# UNITED STATES PATENT AND TRADEMARK OFFICE

APPLICATION NO.	FILING DATE	FIRST NAMED INVENTOR	ATTORNEY DOCKET NO.	CONFIRMATION NO.
10/714,003	11/14/2003	Bruce D. Johnson	J63.202	2086

This is the second Office Action for the serial number 10/714,003, CABLE CLAMP, filed on 11/14/03.

See diagram of Stoneburner shown below for clarification.

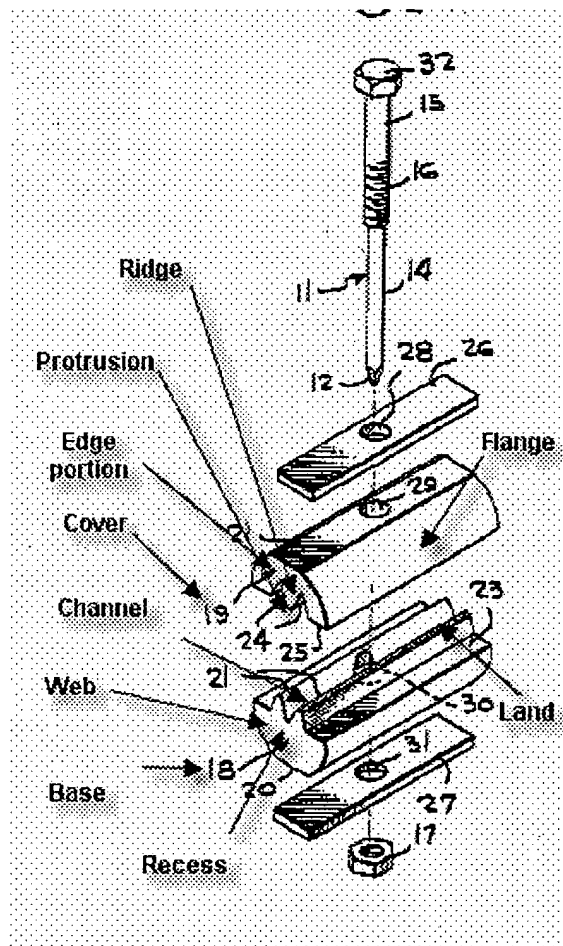
Stoneburner teaches a cable clamp comprising a base (18) including a block of a longitudinal length greater than its transverse width. The block has an upwardly open channel (located between element 21) extending the longitudinal length thereof. The channel having a web surface (located between the walls of element 21) and transversely spaced side walls (21), longitudinally spaced recess (depression part of web) opening upwardly through the web surface and transversely spaced lands (located on top of element 21) that at least in part define the channel side walls. The clamp comprises a longitudinally elongated cover (19) having a top wall with perimetric edge portions, flanges (25) dependingly joined to the top wall edge portions and having transversely opposite longitudinally elongated portions. The cover comprises a longitudinally elongated ridge (located between element 24) dependingly joined to the top wall in transversely spaced, transversely centered relationship to the flange longitudinal portions. The cover ridge being extendable into the base channel and having protrusion (tapered part of

elongated ridge) in about the same longitudinal spaced relationship as the recess. The cover and base being secured by fasteners (32,17). The base and cover have vertically aligned mounting screw aperture (29-30).

between element 21) extending the longitudinal length thereof. The channel having a web surface (located between the walls of element 21) and transversely spaced side walls (21), longitudinally spaced recess (depression part of web) opening upwardly through the web surface and transversely spaced lands (located on top of element 21) that at least in part define the channel side walls. The clamp comprises a longitudinally elongated cover (19) having a top wall with perimetric edge portions, flanges (25) dependingly joined to the top wall edge portions and having transversely opposite longitudinally elongated portions. The cover comprises a longitudinally elongated ridge (located between element 24) dependingly joined to the top wall in transversely spaced, transversely centered relationship to the flange longitudinal portions. The cover ridge being extendable into the base channel and having protrusion (tapered part of elongated ridge) in about the same longitudinal spaced relationship as the recess. The cover and base being secured by fasteners (32,17). The base and cover have vertically aligned mounting screw aperture (29-30).

Applicant's arguments with respect to claims 1-6, 9, 16, 18-23 have been considered but are moot in view of the new ground(s) of rejection.
